**Subject: PALEN SOLAR HOLDINGS, LLC'S RESPONSE TO CEC STAFF DATA
REQUEST SET 2 (19-39)
PALEN SOLAR ELECTRIC GENERATING SYSTEM
DOCKET NO. (09-AFC-7C)**

RESPONSE TO CEC STAFF DATA REQUEST SET 2 (19-39)

PALEN SOLAR ELECTRIC GENERATING SYSTEM

(09-AFC-7C)

Figure DR149- 1: Heliostats retinal irradiance – worst case

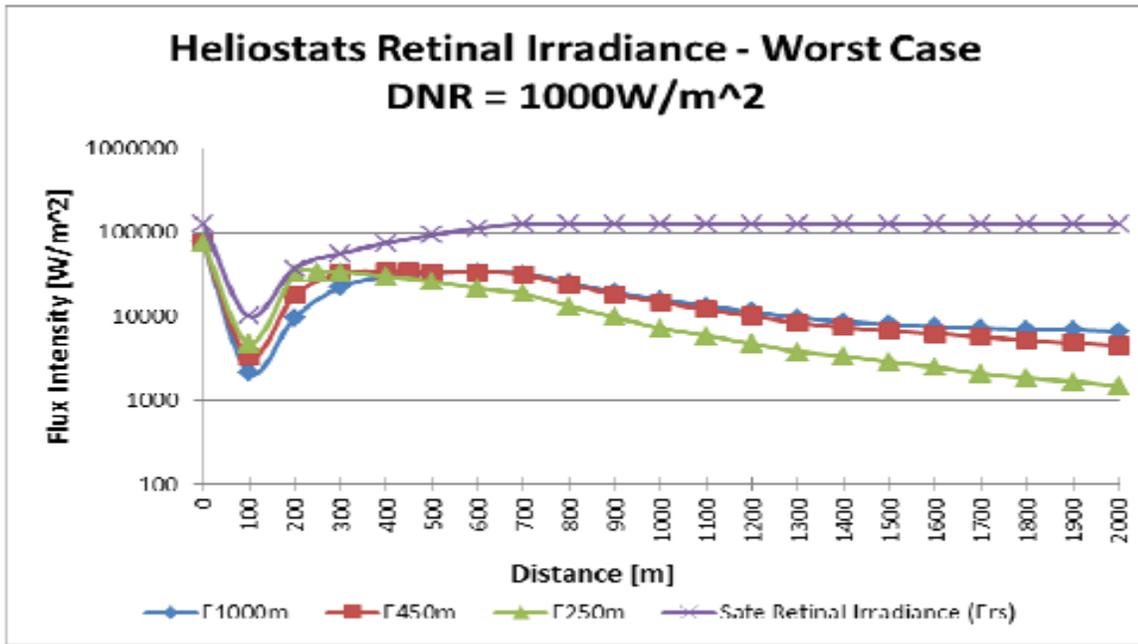
Data Request 35. Please provide the predicted luminance of the solar receiver steam generators from each of the Key Observation Points (KOPs), including those described in Data Request 39, below.

Data Response 35. Tower Luminance

The luminance of the receiver is lower than 10^6 cd/m². The sun luminance at noon is $1.6 \cdot 10^9$ cd/m². The receiver luminance is computed as if you are viewing it from the same elevation as the receiver. The actual luminance on the ground should be slightly lower. Luminance does not change significantly with distance. However, the effect of an object of certain luminance on the retina depends on the angular size of the object, which decreases with distance.

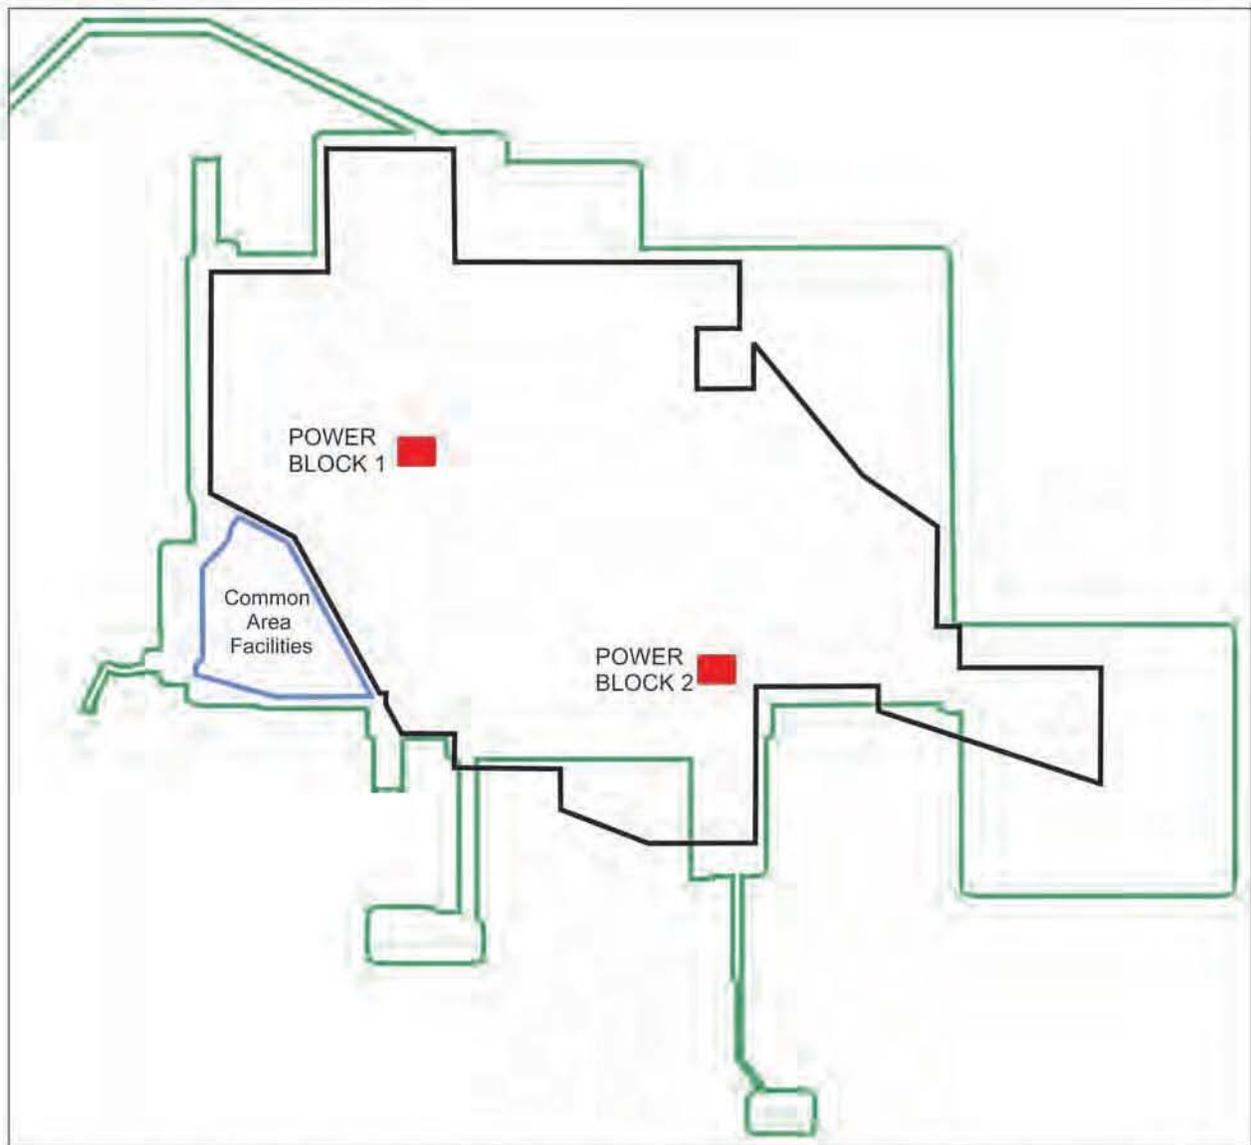
Data Request 24. *Please design and conduct a class II pedestrian archaeological survey of the original project area sufficient to verify the statistical validity of the cultural resources inventory for the project area as documented in 2009 and 2010.*

The project has since been modified (Figure 1) by reducing the footprint's acreage on the northeast corner and by extending the project's footprint to the south in two small areas. Additional studies have been requested by the BLM and the CEC. These additional studies include:

Figure 2. Map of revised PSEGS footprint area showing areas not previously surveyed for archaeology (in blue). These areas are designated for Class III archaeological surveys. Topographic map base is USGS 7.5' Sidewinder Well Quadrangle.

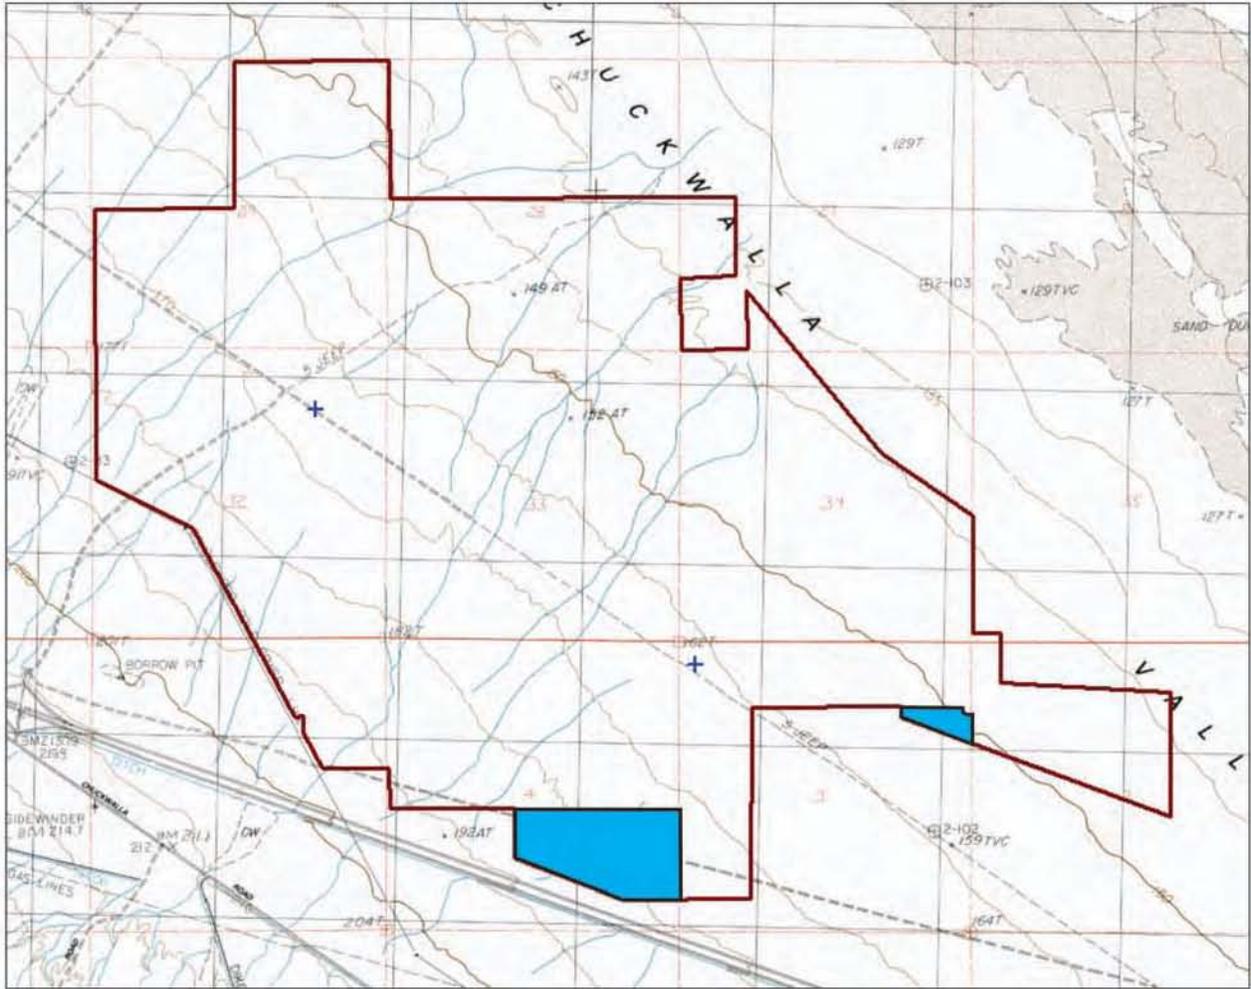
Data Request 22. *Please design and conduct a class III pedestrian archaeological survey, per the Energy Commission's siting regulations, of the natural gas pipeline corridor that would be associated with the construction and operation of the amended project.*

Due to the change in the PSEGS footprint from the Palen Solar Project footprint, two parcels were not surveyed for the Palen Solar Project that require a BLM Class III inventory: parcel 1(~95 acres on the southern end of the project just south/southwest of Power Block 2 in the center and the SE ¼ of section 4, T 6 South, R 17 East) and parcel 2 (~15 acres on the more southeastern part of the project area in the NW ¼of section 2 and the NE ¼ of section 3, T 6 South, R 17 East) (Figure 2). Both parcels shall have a 200' buffer extending outside of the PSEGS ROW application area boundary.

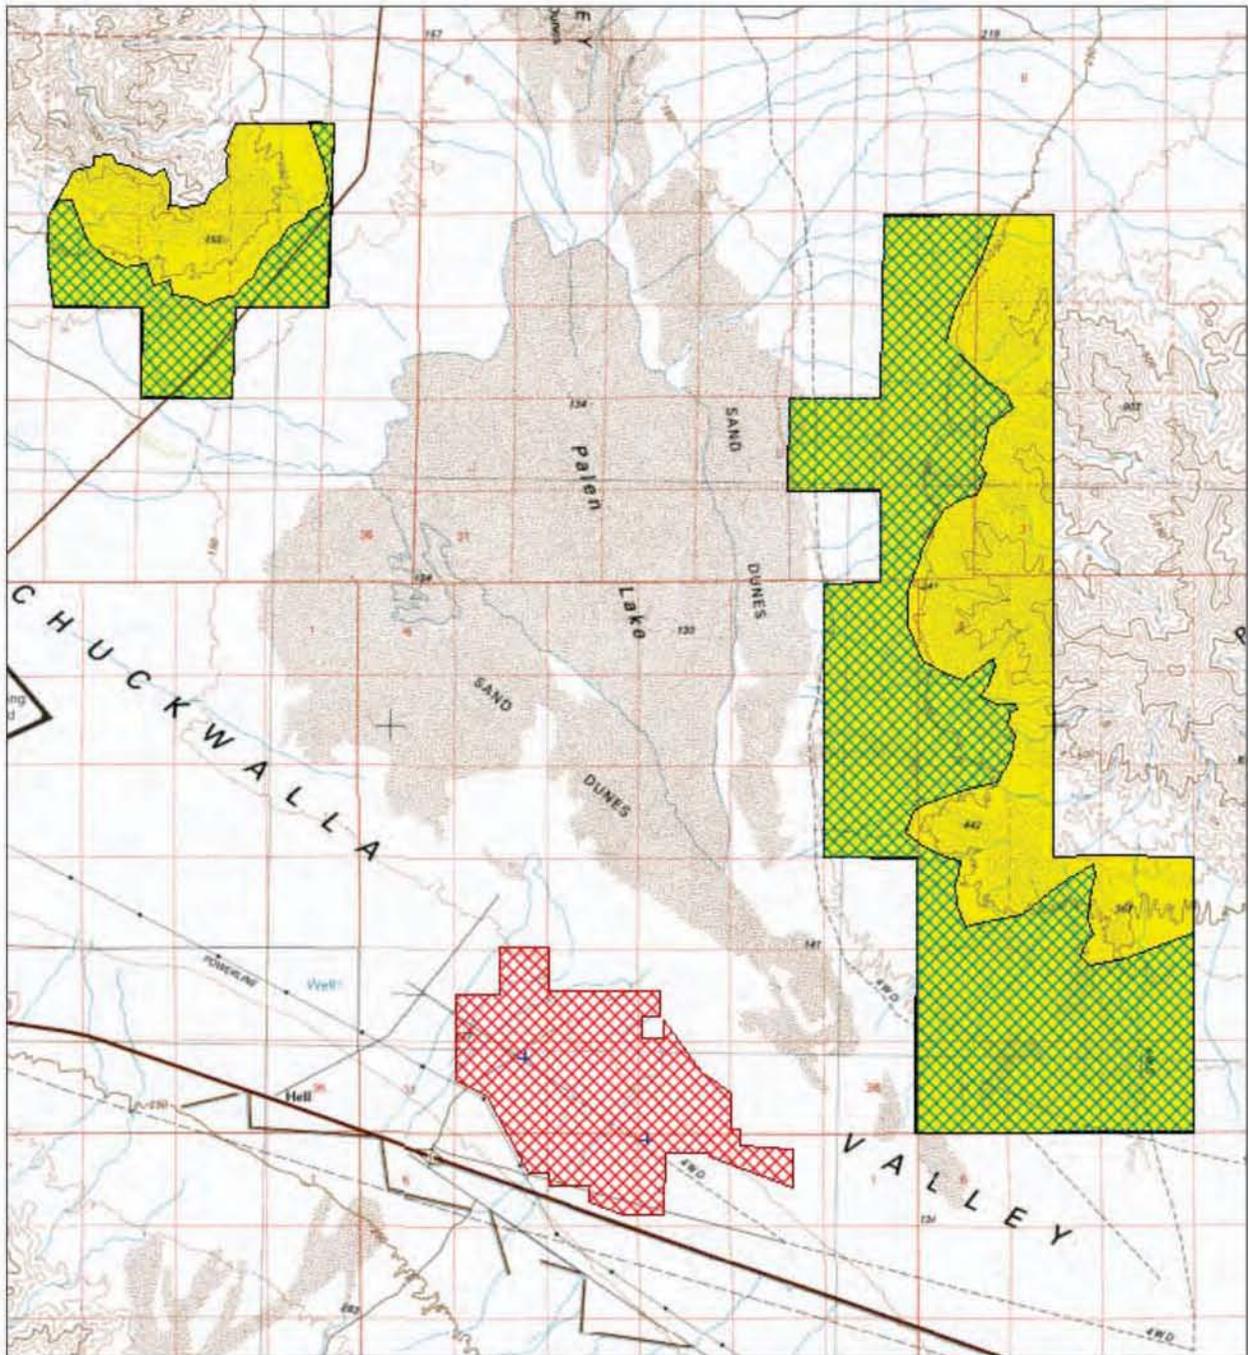
Data Request 27. *Please design and conduct reconnaissance pedestrian (class II) surveys of the portions of the southwestern Palen Mountains¹ and of the southern Coxcomb Mountains² that fall within sight of the solar power towers for proposed Units 1 and 2 of the amended project. The relatively exclusive focus of the surveys should be archaeological resources that have the potential to be eligible for listing in the CRHR under Criteria 1 and 3. Such resources would typically include, but would not be limited to, rock art, intaglios, caves that may evidence ritual use, apparent altars or shrines, cleared circles, rock cairns, and trail segments. An archaeological deposit that may represent locally atypical economic behavior may also qualify for consideration for its associative value as well as its inherent information value. Staff is aware that the majority of these survey areas are in remote places that lack vehicular access.*

Since this was a joint request from CEC and BLM, BLM has required that the methodology for conducting the surveys requested by this data request be included in the Workplan. PSH has complied with BLM's request. Therefore, as described in response to Data Request 25 above, since the Workplan is being circulated for comment, BLM has not yet issued a fieldwork authorization to conduct this work. Additionally, PSH was told by BLM that it could not use a helicopter to support and facilitate this work effort.
